Memorandum

4 November 2019

To	Douglas Shire Council and Department of State Development, Manufacturing, Infrastructure and Planning		
From	Sarah Wilson - GHD	Tel	+61 7 5413 8133
Subject	Response to information request from Douglas Shire Council (DSC) and Department of State Development, Manufacturing, Infrastructure and Planning (DSDMIP) Wangetti Trail SP1 - Combined Development Application Response to request for information 1909-13127 SRA	Job no.	4132458

Print date: 31 Oct 2019 - 12:19

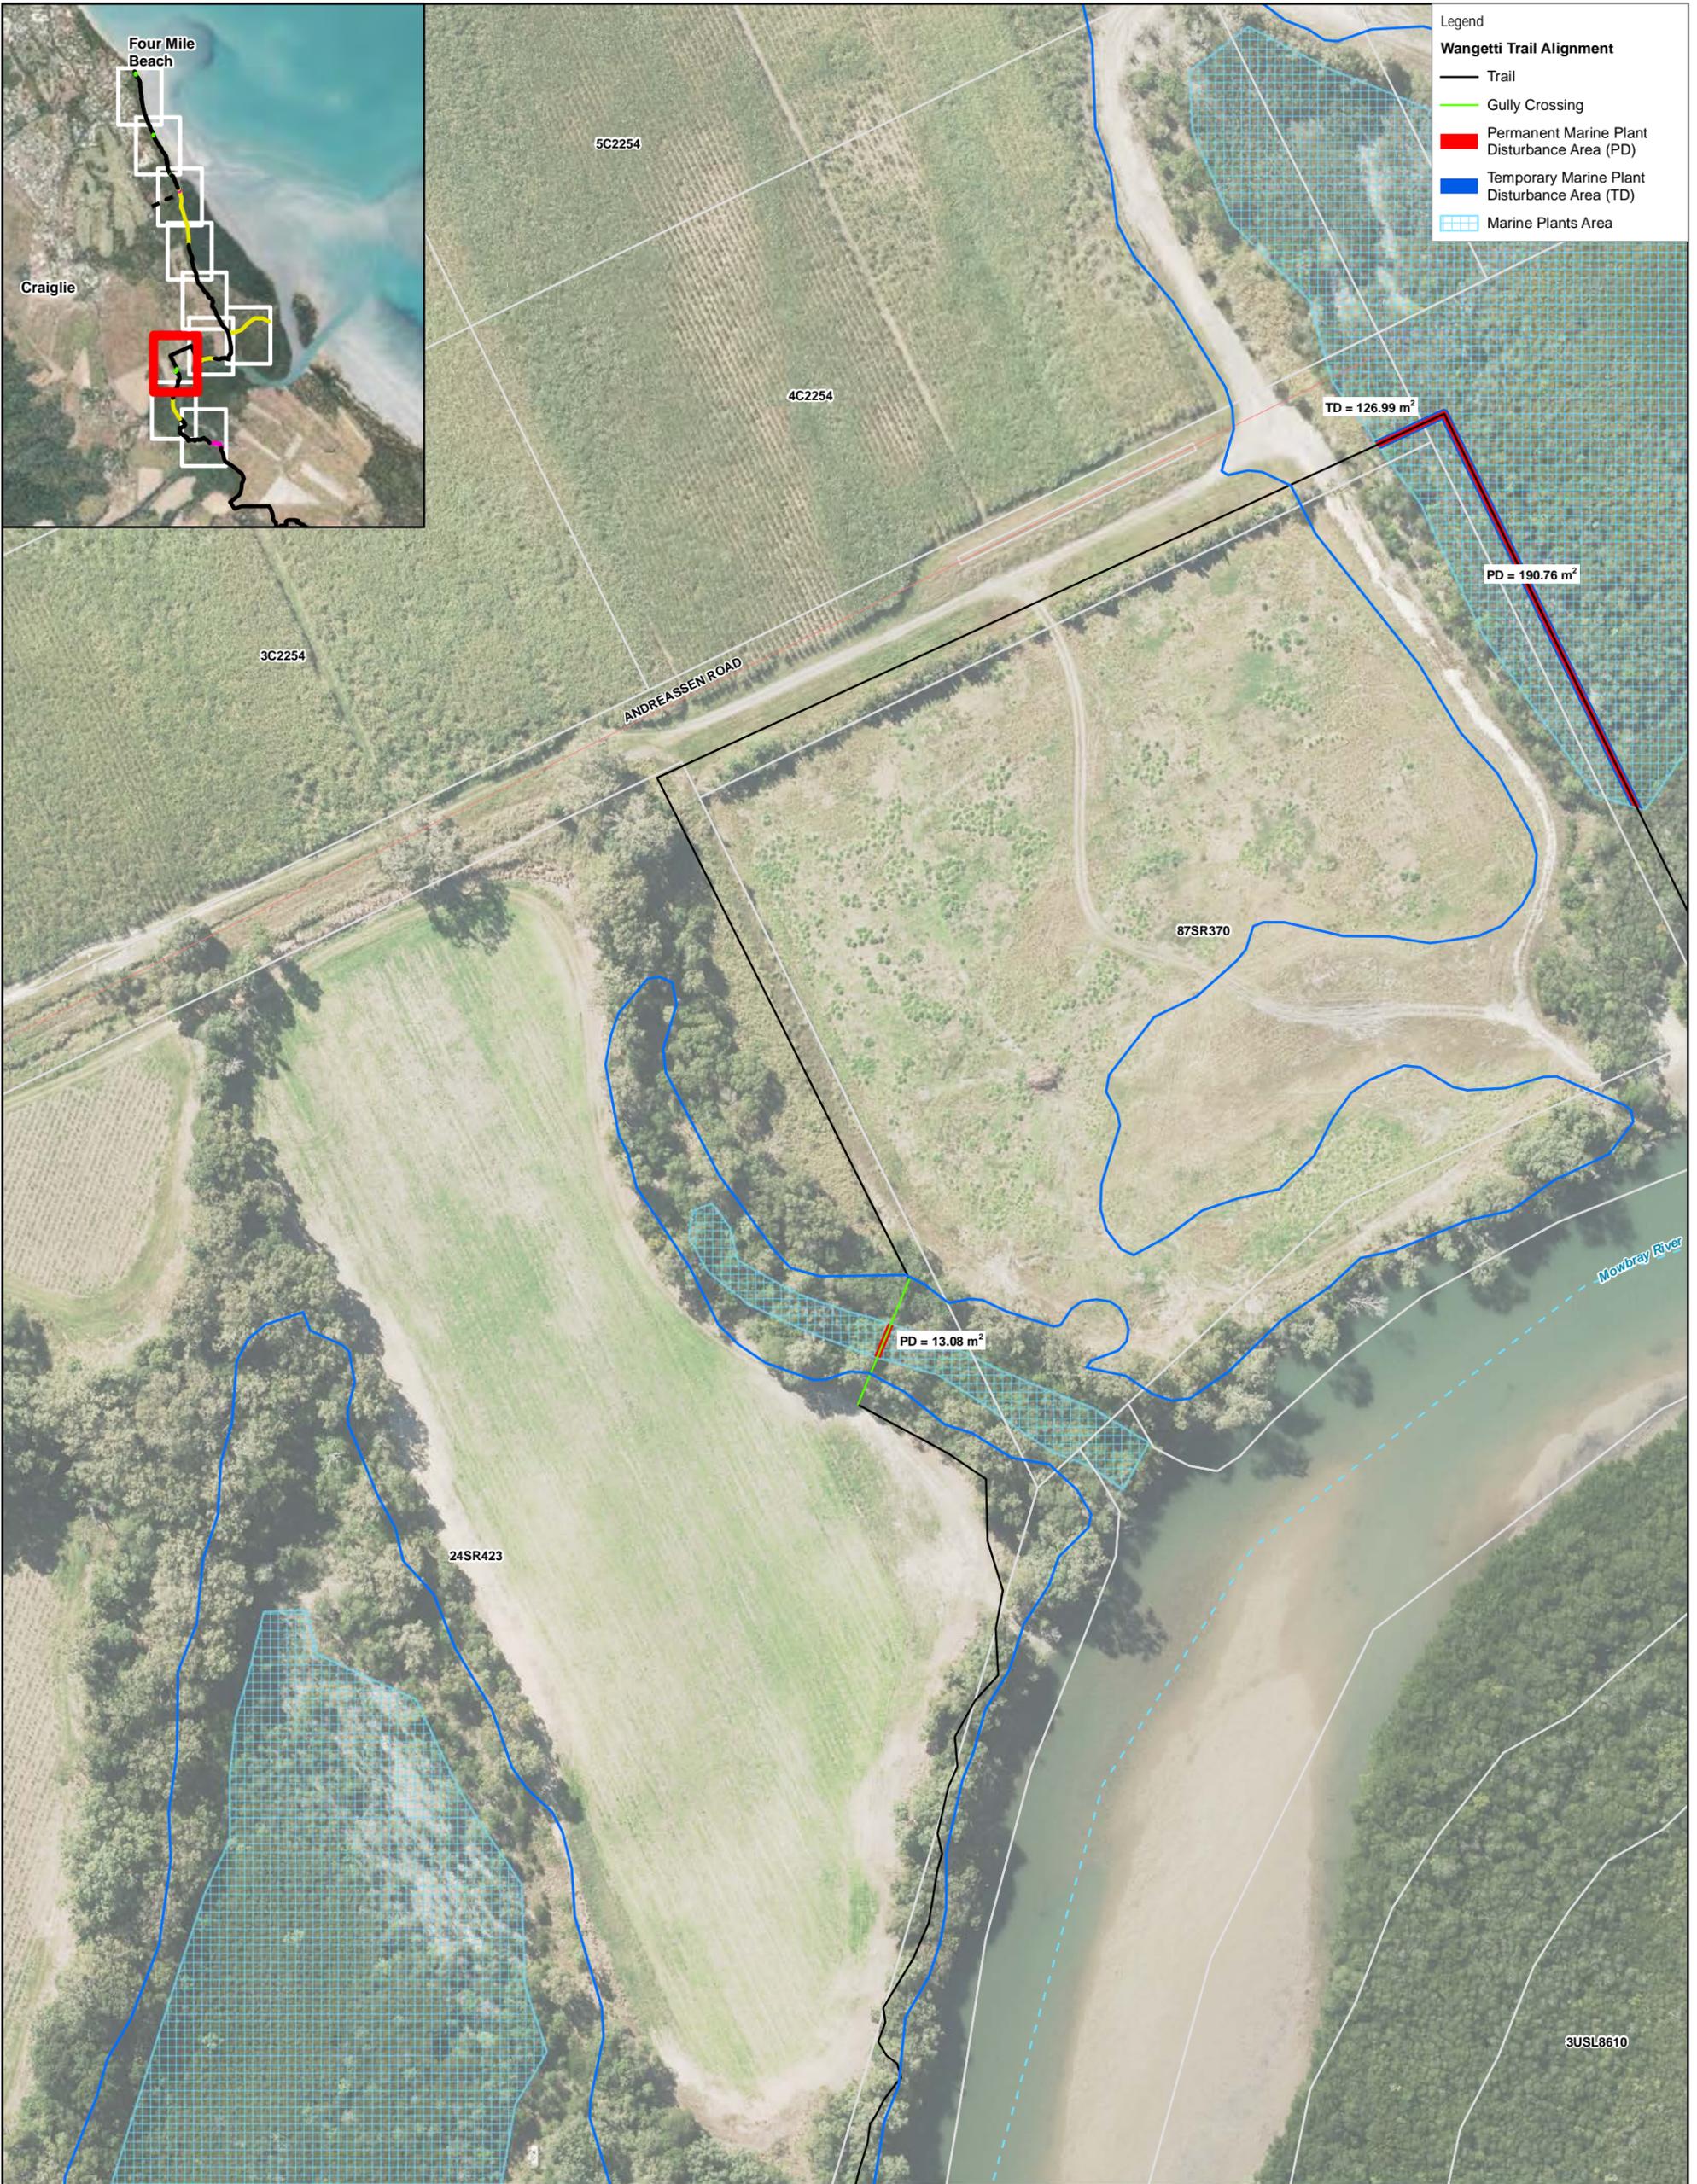
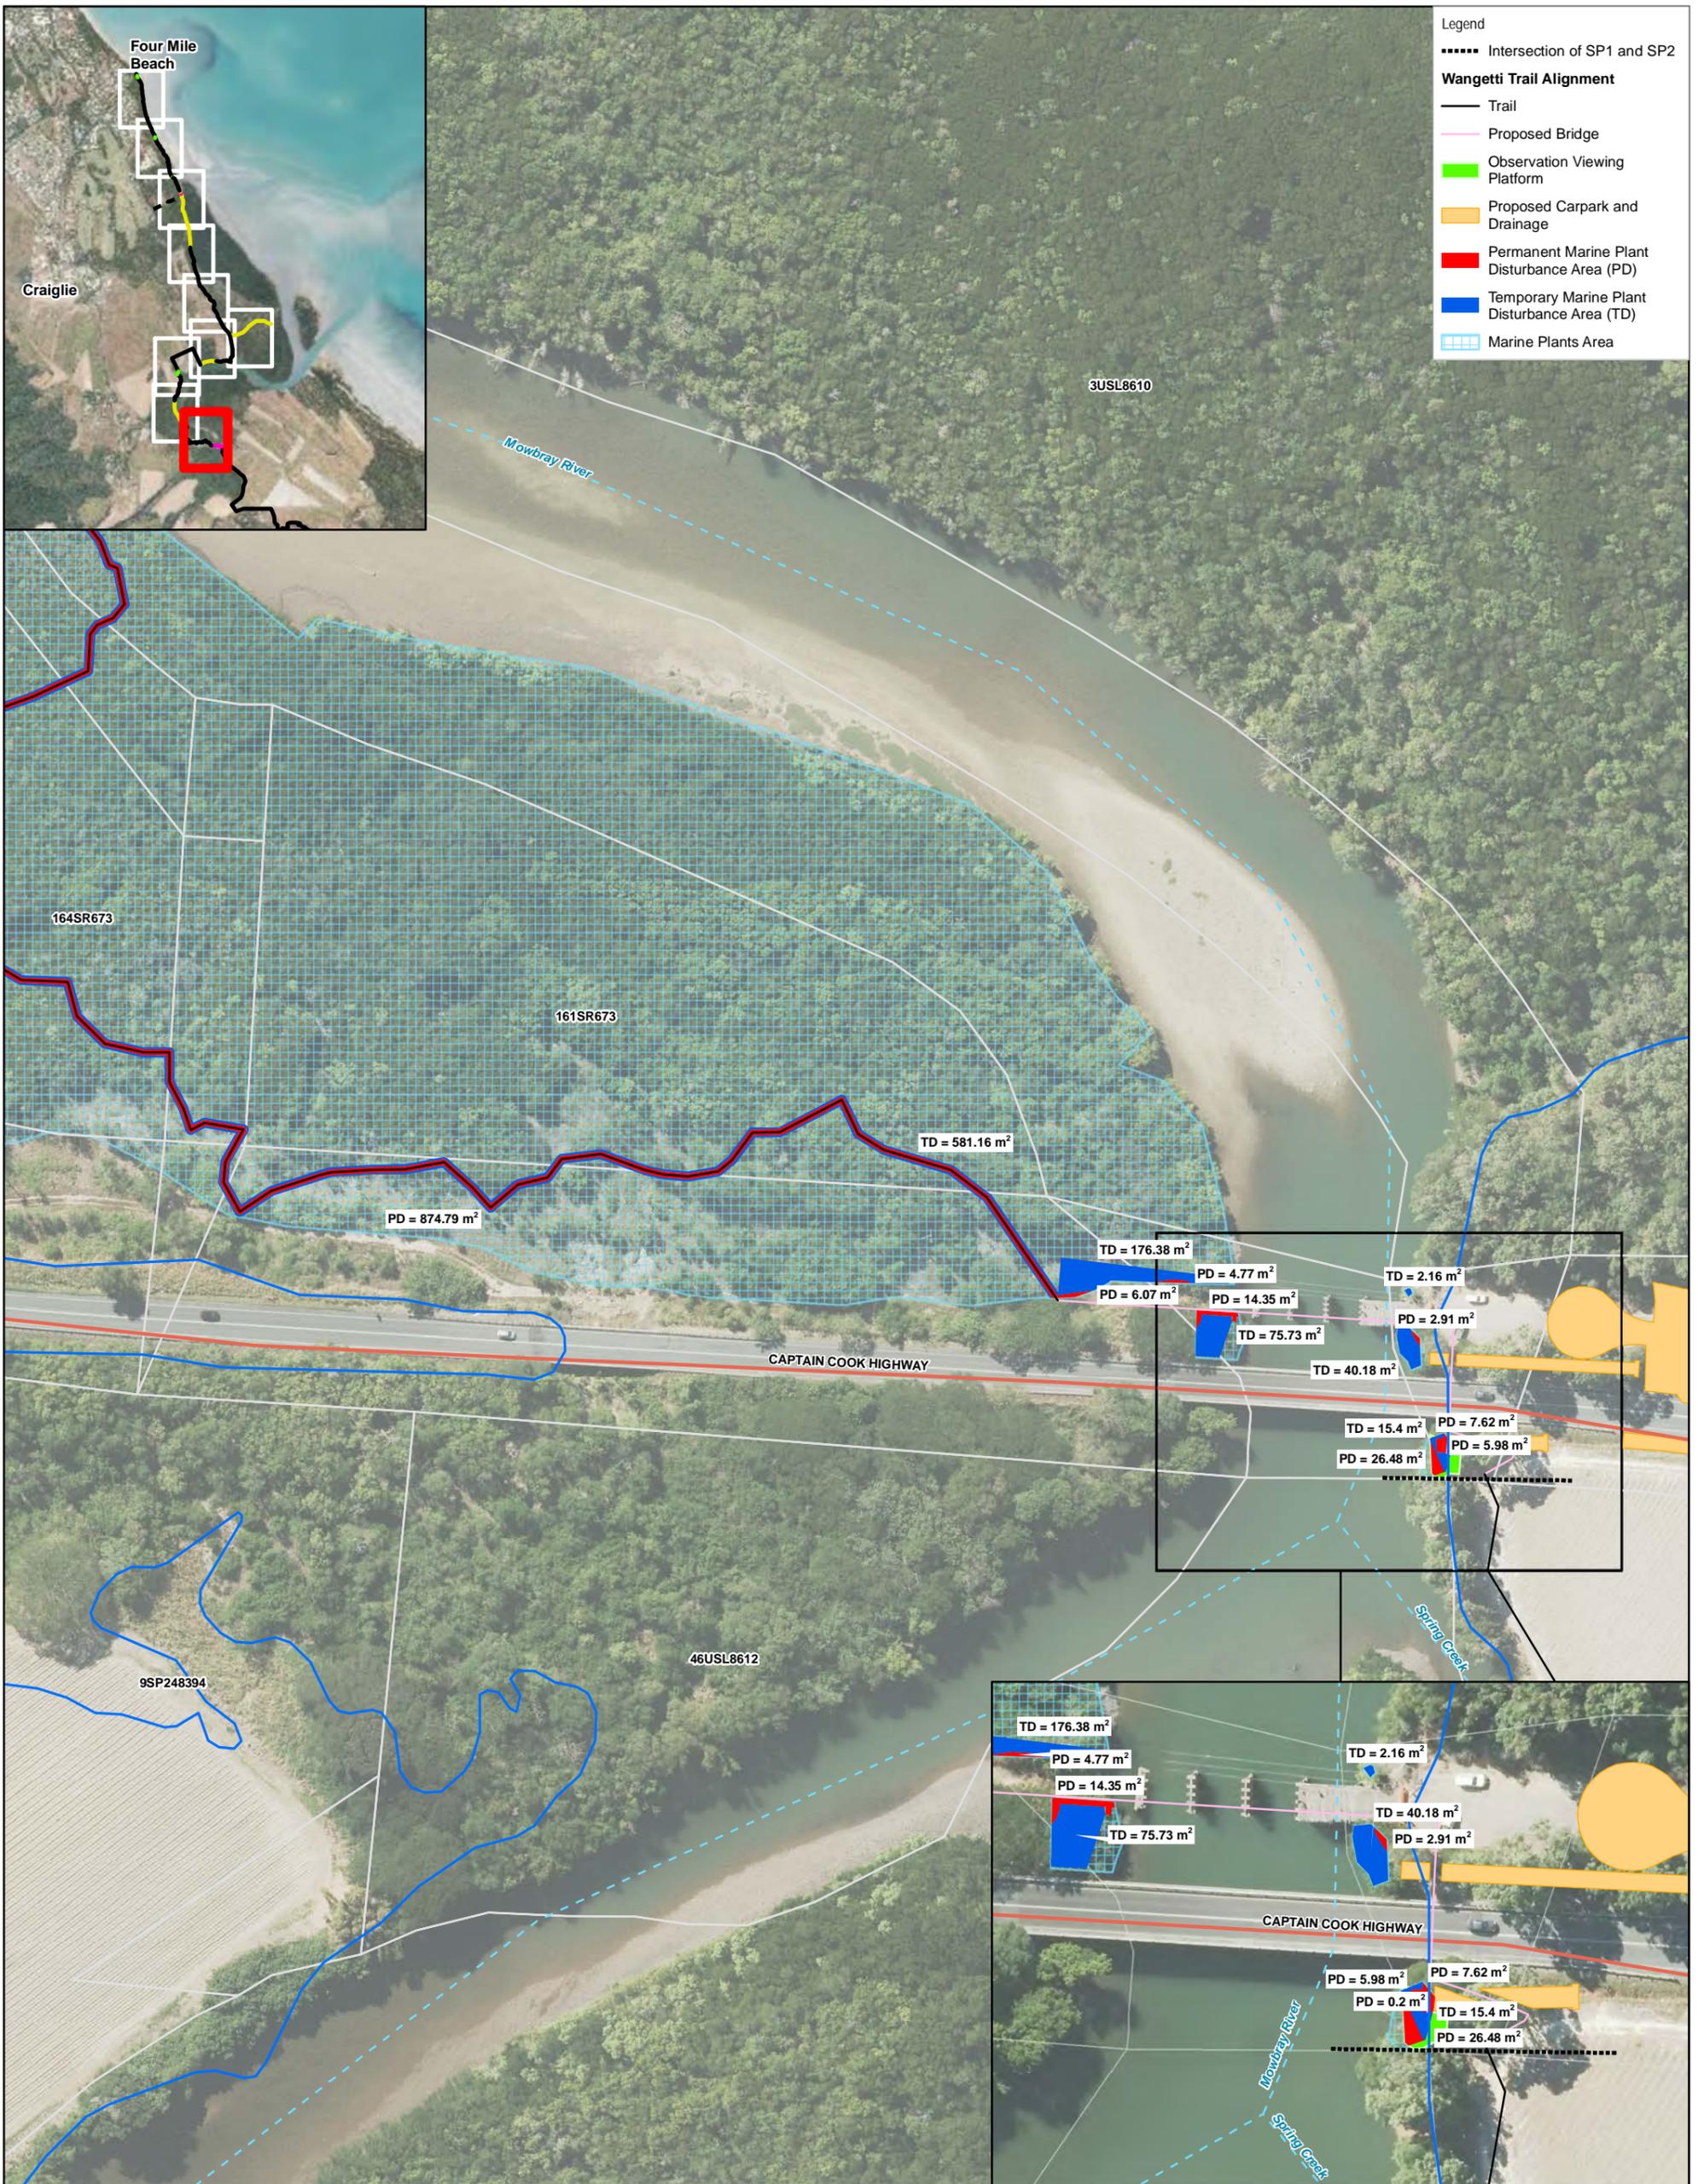
- a) Provide construction plans detailing the location and elevation of the mangrove experience board walk and observation deck.*
- b) Submit scaled drawings of the permanent and temporary disturbance areas for all ancillary infrastructure proposed at Mowbray River location.*
- c) Provide the individual marine plant disturbance area in meters squared (m²) for each works component.*
- d) Provide updated marine plant disturbance areas accounting for high fisheries significant plants.*

Item 3 (c) Provide the individual marine plant disturbance area in meters squared (m²) for each works component.

Figure 2 shows the location of the proposed trail and boardwalk and the location of threatened ecological community (TEC) - Littoral rainforests and coastal vine thickets of eastern Australia. The SP1 alignment has been designed to predominantly avoid areas of TEC, however the trail intersects with a small area of TEC, located approximately 600 m north of the Mowbray River. The TEC was not previously mapped in government databases and was recorded during the site investigation of the area. Based on the composition of the vegetation within the TEC area, it was determined not to contain high fisheries significant plants.

A breakdown of the marine plant disturbance including temporary and permanent disturbance has been provided in Table 3-2 of the Environment Assessment Stage 2 Wangetti Trail Planning Report for Operational Work - SP1 Marine Plant Disturbance Report and is outlined in Table 5 below and shown in Figure 2.
